**STATE OF TENNESSEE
DEPARTMENT OF TRANSPORTATION**

INSTRUCTIONAL BULLETIN NO. 17-09

Regarding Revised Standard Drawings

Effective February 9th, 2018 letting (November 29th, 2017 Turn-in), the following Standard Drawings have been revised. Also, Section 5, Index of Standard Drawings, of the Roadway Design Guidelines has been revised to incorporate these changes.

10-15-02 RD01-TS-2

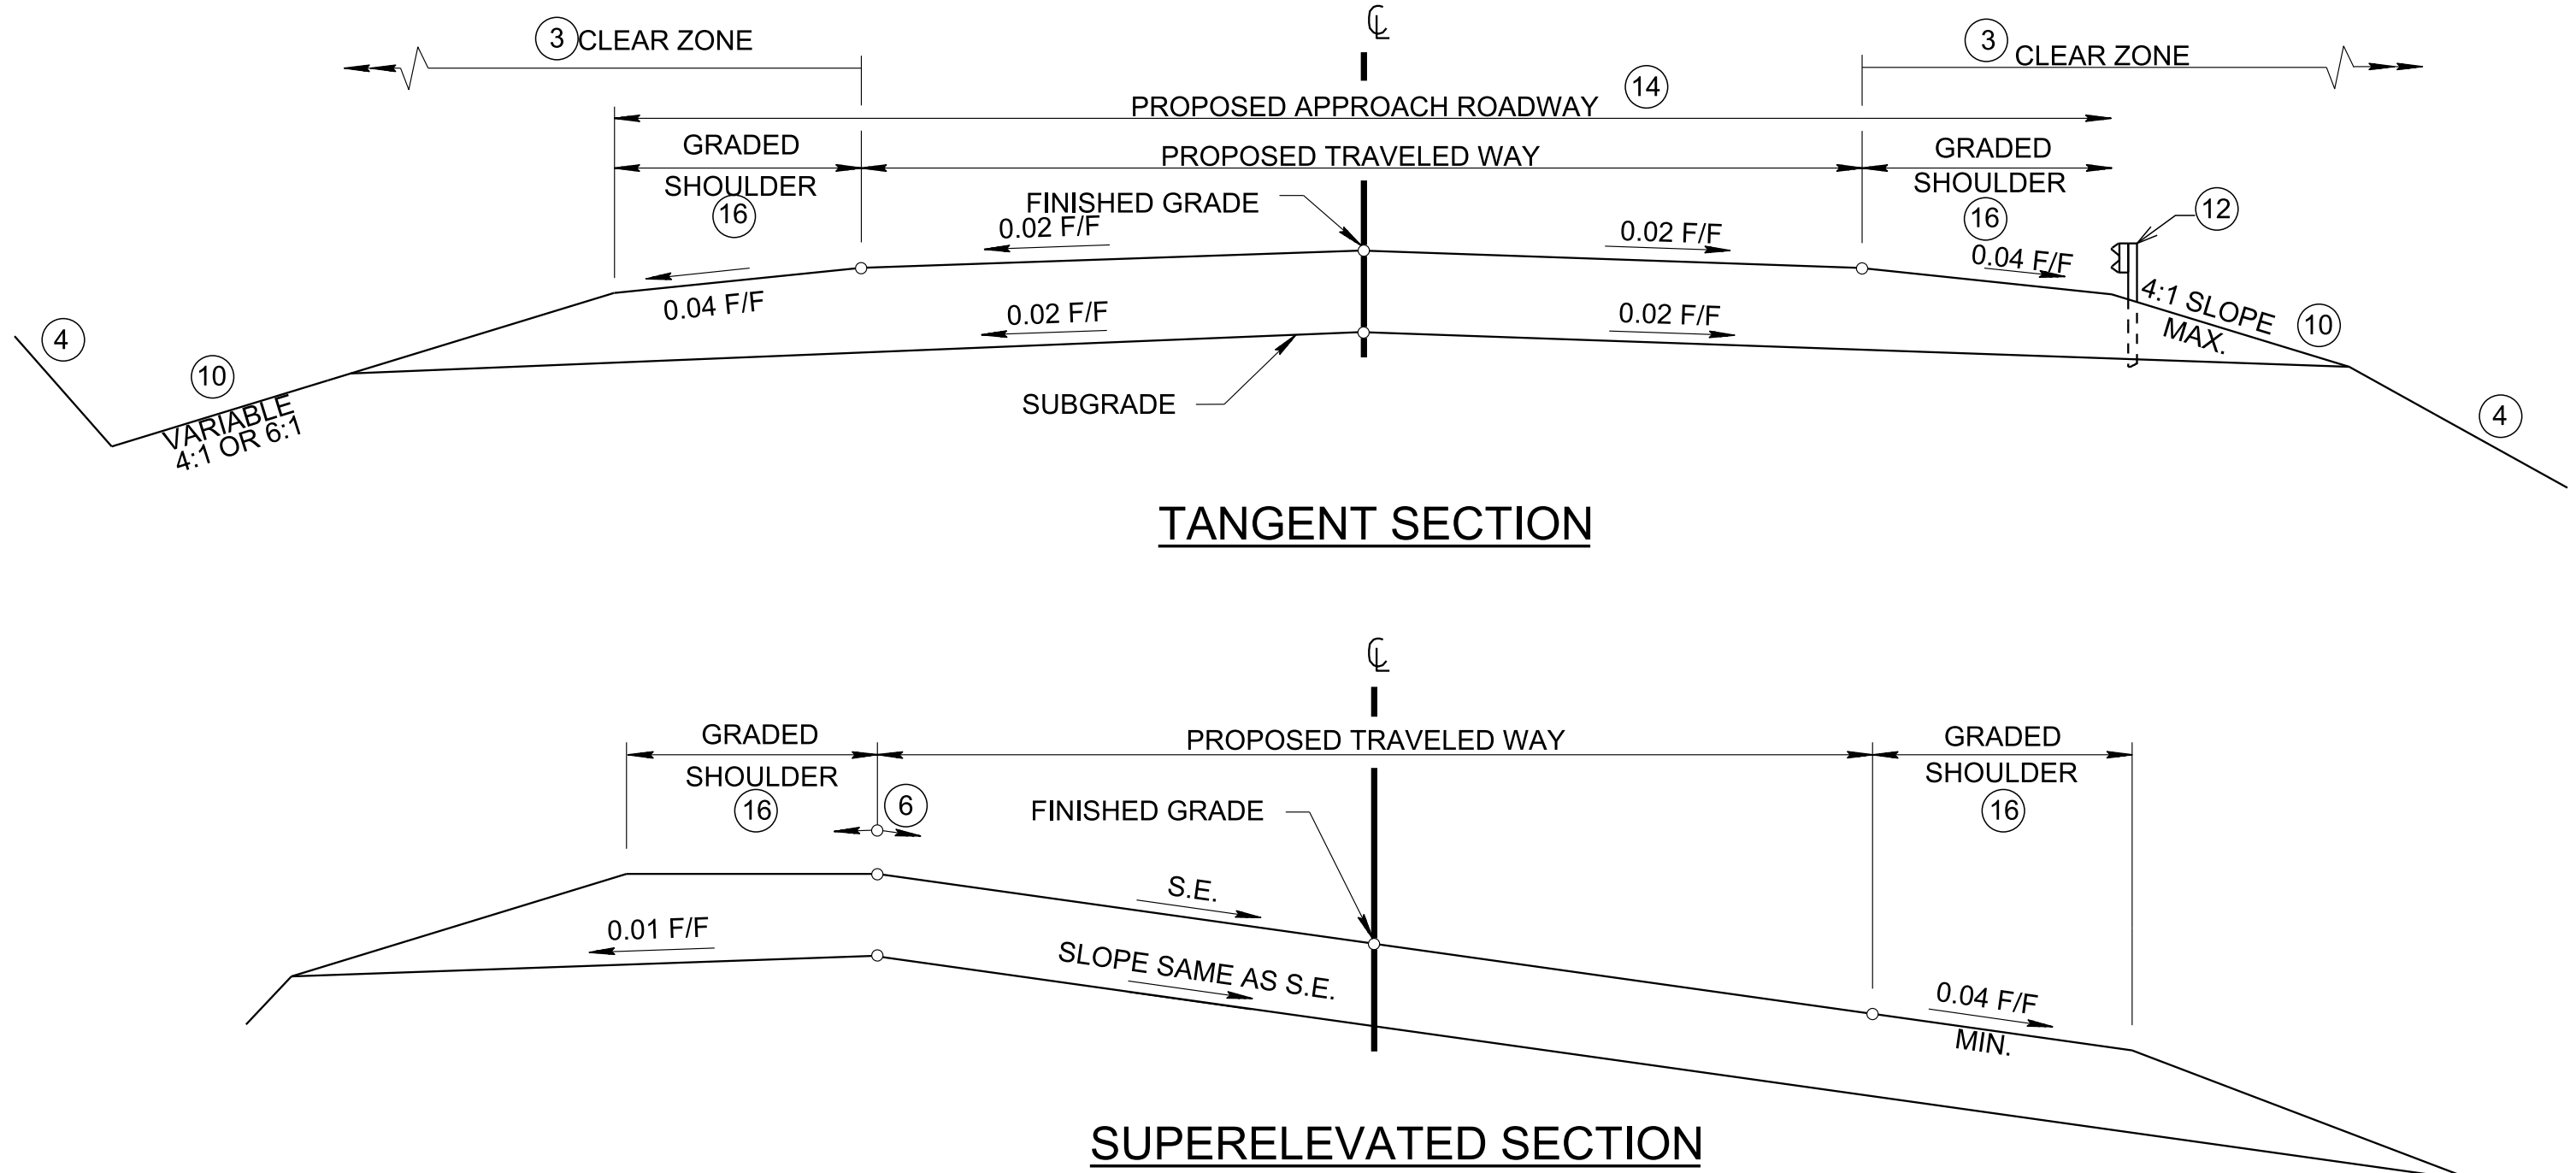
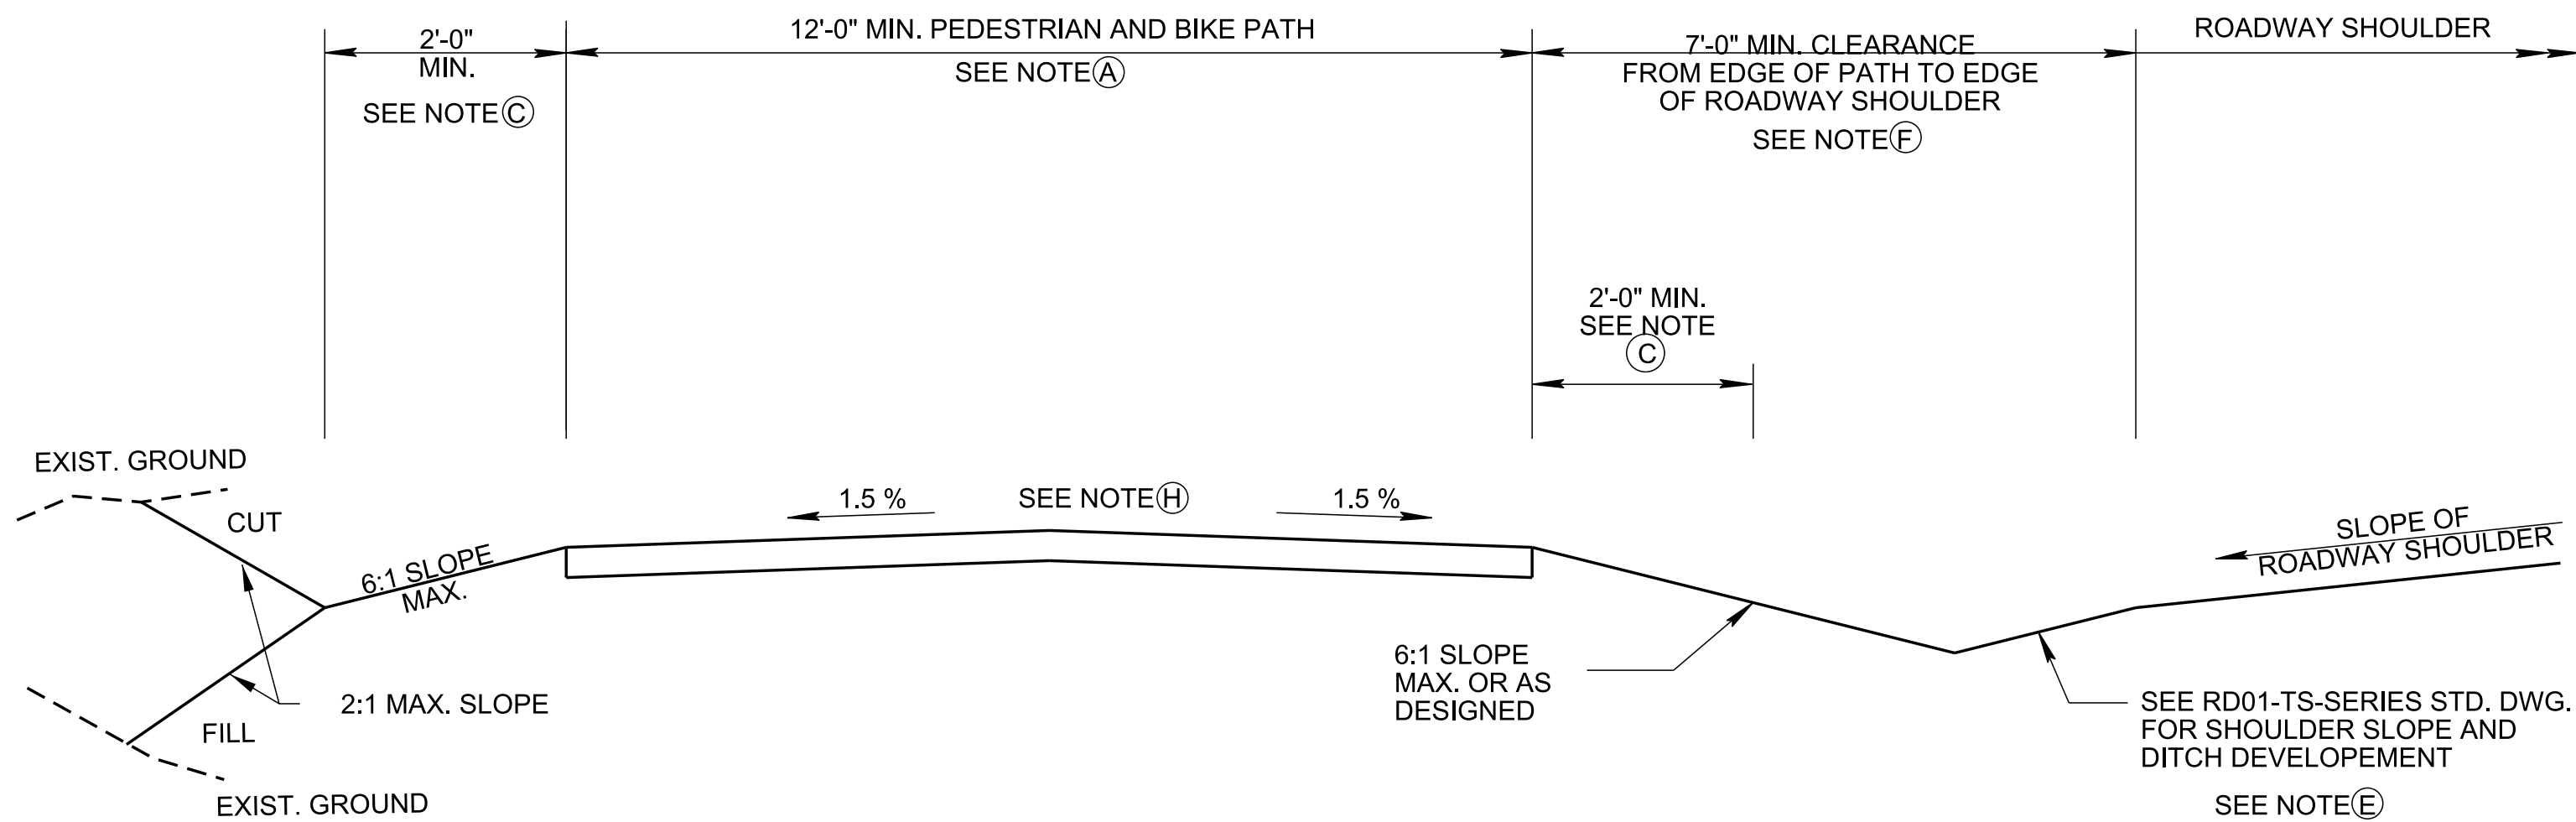
REV. 3-16-17: UPDATED DESIGN
LOADING TO HL-93, UPDATED
GENERAL NOTE C, "2002" TO "2011",
UPDATED FOOTNOTE ③ "RD01-S-12"
TO "S-CZ-1" AND "2002" TO "2011".
UPDATED FOOTNOTE ⑫
REMOVED DETAIL A.

S-GRS-4

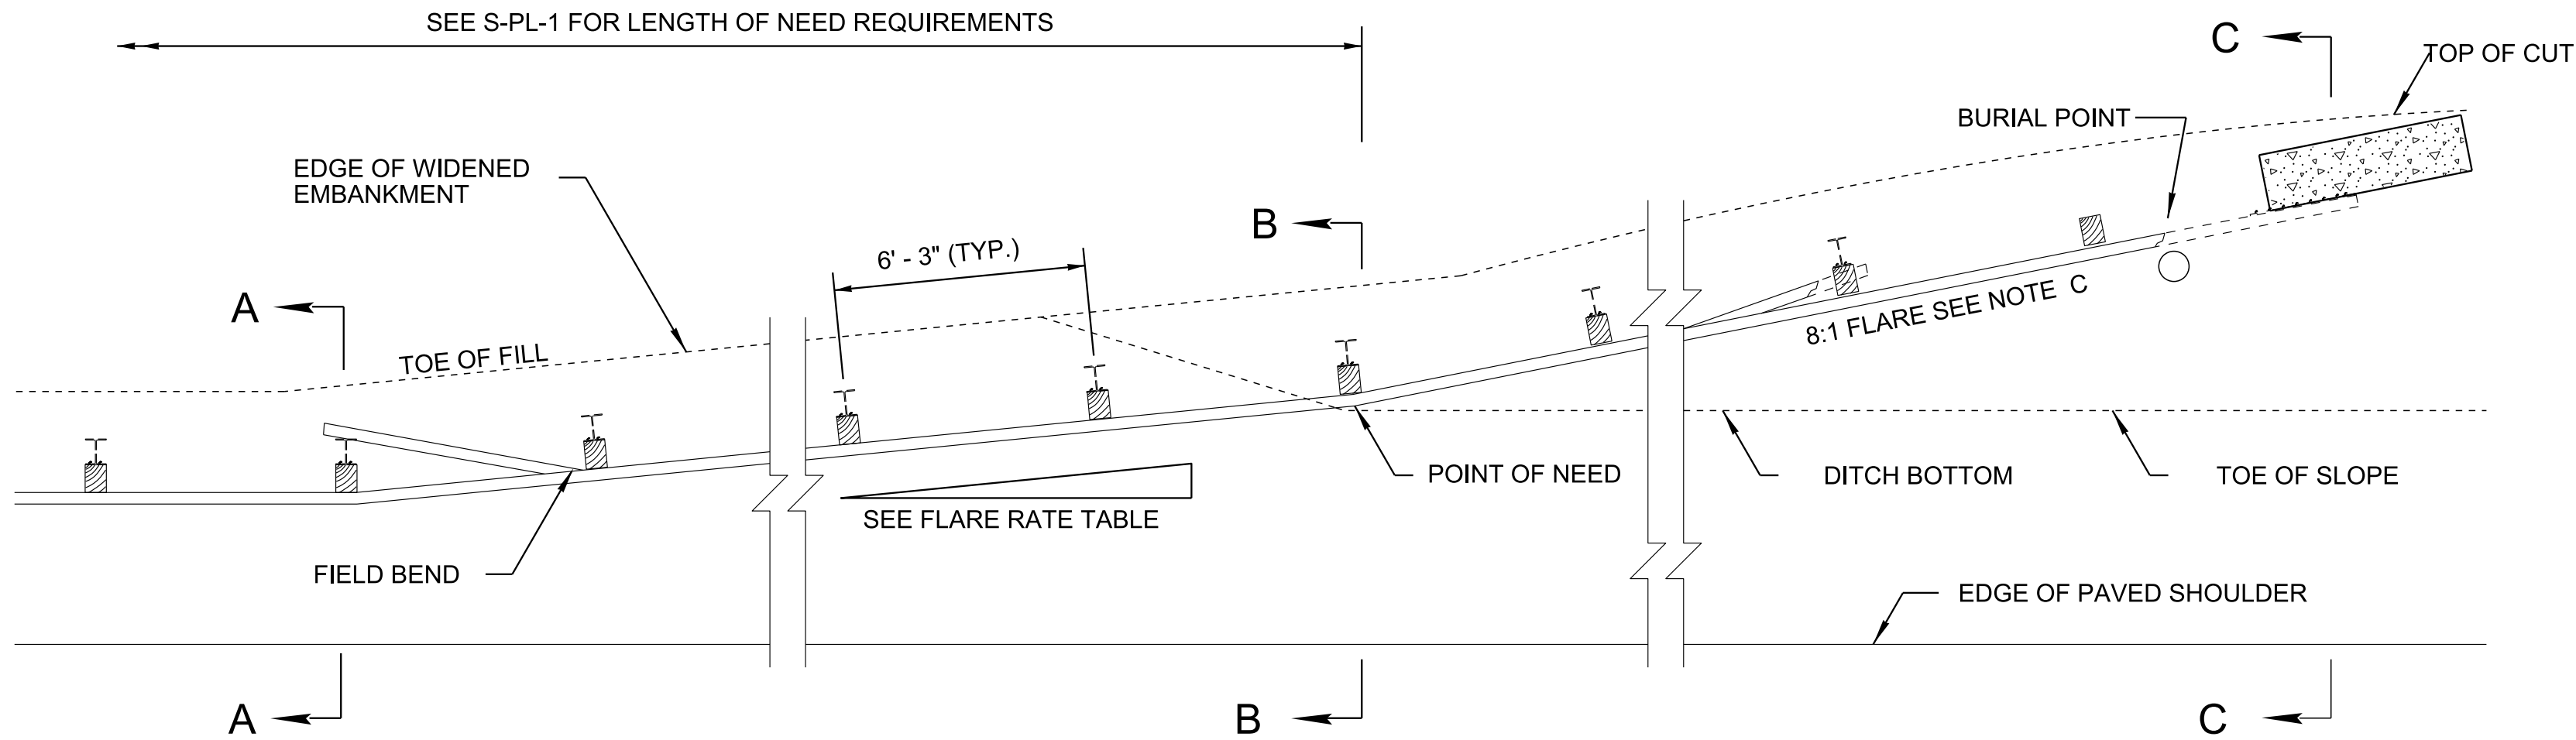
- REV. 4-12-16: ADDED PAY ITEM.
- REV. 3-16-17: CLARIFIED PAY ITEM LIMITS AT BOTH ENDS OF TRANSITION.
